PRELIMINARY PLAT AMENDMENT STAFF REPORT WILLOW CHASE

PETITION NO.: 04-03PP.1

REQUEST: Preliminary plat amendment petition to request modification of the landscape plan that was approved with the original subdivision.

2004 Approved Landscape Plan

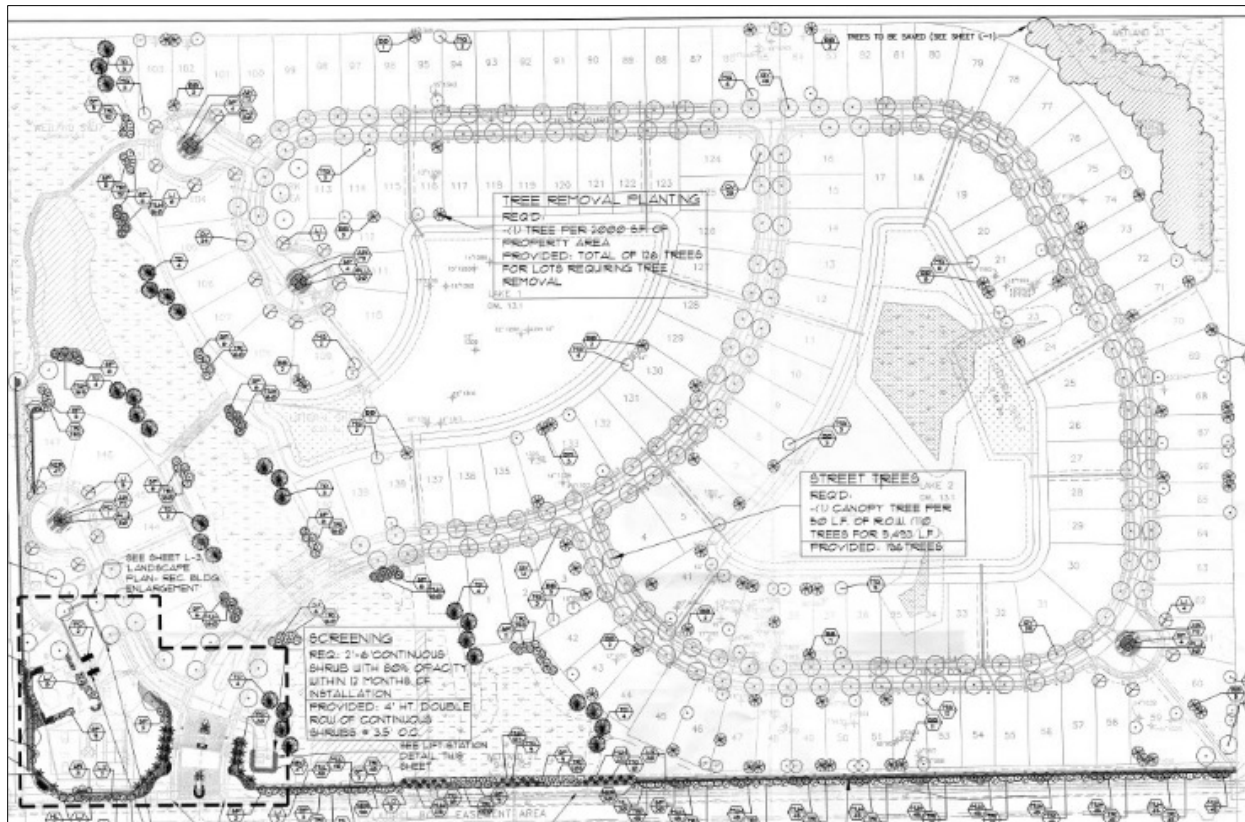
The Willow Chase residential subdivision was approved in 2004. Within recent years, the community association has expressed concerns regarding the larger street trees, especially live oak trees, that have caused damage to sidewalks along with other infrastructure. This damage has been an ongoing maintenance and safety issue for the association as the damage is typically located within the common areas the association is responsible for. In an attempt to resolve the issue, the association created a phasing plan through which the live oak street trees would be removed and, in some cases, relocated to other more suitable common area within the subdivision. The removed and relocated trees would then be replaced with tree species that are less likely to cause damage to adjacent infrastructure.

In addition to the street tree issue, the 2004 plan depicted required trees on private lots. The reason this occurs is that sometimes it is difficult for an applicant to comply with the total number of trees required by the Sarasota County tree code without depicting trees on private lots. There sometimes is simply not enough space to accommodate all the trees without including plantings on private lots. This is something that the City currently tries to avoid when subdivision plans are being considered. The problem comes about upon approval of a landscape plan that depicts a tree on a private lot; that tree is now required to be in place for the life of the subdivision. Even if the homeowner desires to remove the tree, they cannot and maintain compliance with the approved plan. In addition, the applicant has indicated that many of the trees that are depicted on the approved plan on private lots were never installed. Although the majority of lots contain at least one tree, it may not be the approved species and location shown in the approved plan. The proposed petition will resolve this issue by removing all trees depicted on private lots from the proposed plan.

2004 Approved Landscape Plan with Highlighted Areas of Revision

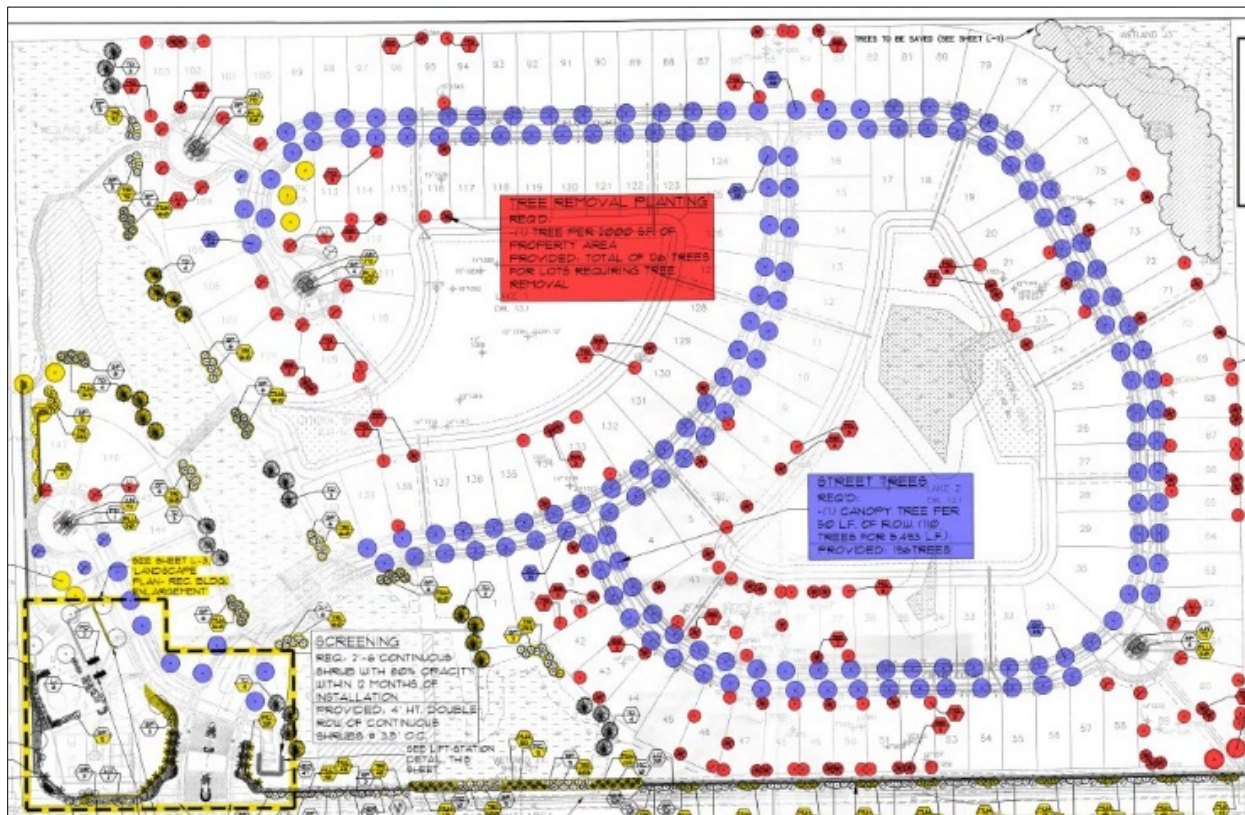
Areas where trees have been removed.

Existing live oaks

Laurel Road buffer

Alternative replacement tree species

The “Proposed Planting List” provided in the revised landscape plan is consistent with these requirements. It is important to note that much of the material onsite will remain unchanged and will be confirmed compliant through this process. Therefore, the subject petition may be found consistent with the City’s LDC.
